Access Compliance Report

Public Rights-of-Way

(Curb Ramps)

Intersection ID: 2500	Main Street: CAMBRIDGE_BAY_DR	Cross Street: VISCOUNT_LN	Location: NW
ADA ID: F0A118FBA4F1	Ramp Type: Perp	Initial Pass/Fail: Fail	Overall Compliance: No
Severity Score: 12.5			
Codes/Mitigation Info/Possible Solution		Field Measurements/Component Compliance

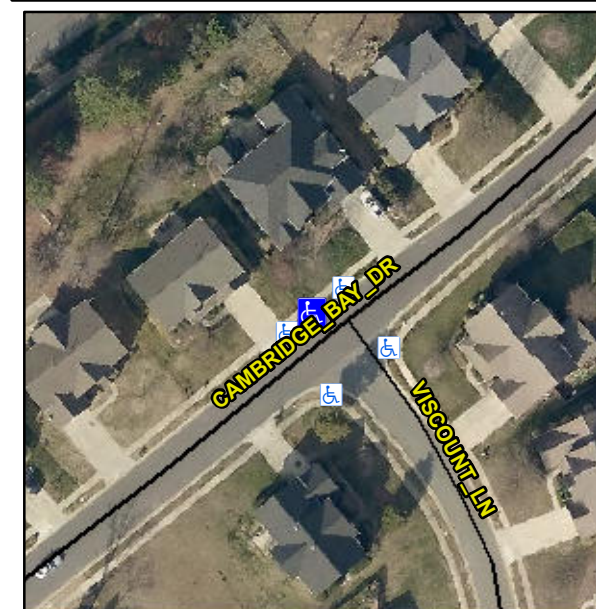
Not Found, R304.2.2

Compliance	Description	Data	Compliance	Description	Data
N/A	Ramp Length (in)	47.0	No	Ramp Slope (%)	11.1
Yes	Ramp Width (in)	48.0	Yes	Ramp XSlope (%)	1.4
N/A	Flare Type LT	N/A	N/A	Flare Type RT	N/A
N/A	Flare Slope LT (%)	N/A	N/A	Flare Slope RT (%)	N/A
N/A	Flare Traversable LT?	N/A	N/A	Flare Traversable RT?	N/A
N/A	Landing Length (in)	N/A	N/A	DWS Provided?	N/A
N/A	Landing Width (in)	N/A	N/A	DWS Contrast?	N/A
N/A	Landing Slope (%)	N/A	N/A	DWS Length (in)	N/A
N/A	Landing X Slope (%)	N/A	N/A	DWS Full Width?	N/A
N/A	Landing Curb? (Y/N)	N/A	N/A	DWS Offset (in)	N/A
N/A	Shared Landing?	N/A			
N/A	Gutter Ponding?	N/A	N/A	Gutter Slope (%)	N/A
N/A	Gutter Lip Ht (in)	N/A	N/A	Gutter X Slope (%)	N/A
N/A	Painted X Walk1?	No	N/A	Painted X Walk2?	N/A
	X Walk 1 Direction	To SE		X Walk 2 Direction	N/A
N/A	X Walk 1 Width (in)	N/A	N/A	X Walk 2 Width (in)	N/A
	X Walk 1 Slope (%)	3.9		X Walk 2 Slope (%)	N/A
	X Walk 1 X Slope (%)	0.4		X Walk 2 X Slope (%)	N/A

Remove & Replace Entire Ramp.
